SWAG 20 93 9925, 20 10 2532, 20 10 4870, 20 10 4871

To fit:
various BMW models
without M-Sport suspension.

Strut mounting with friction bearing

Figure 1 - SWAG 20 93 9925: 3-hole M10

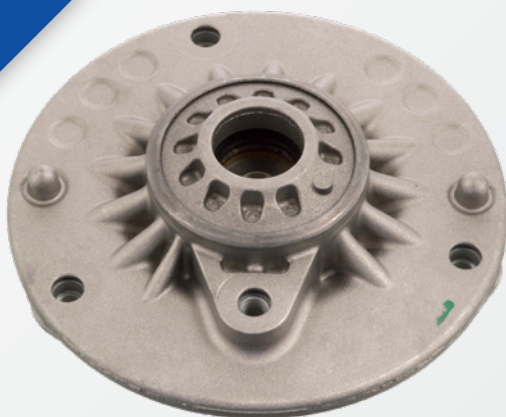
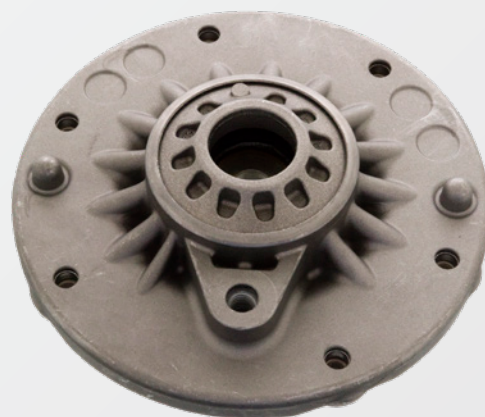
Check which version of the strut mounting and thread size is fitted to the vehicle before replacing!

In the case of the F2x and F3x models up to model year 05/2013:

If the strut mounting with a M8 thread is fitted, the strut mountings must be replaced in pairs by using two strut mounting kits (20 10 4871) with the M10 thread. This includes all fixings, suspension- strut buffer and dust cover.

The changeover of thread M8 to M10 results in a different level of stiffness. Therefore, a mixed installation of mountings (M8/M10) is not permitted!

If the strut mountings have already been replaced once with the M10 thread mounting, the installation of an individual strut mounting is permissible.
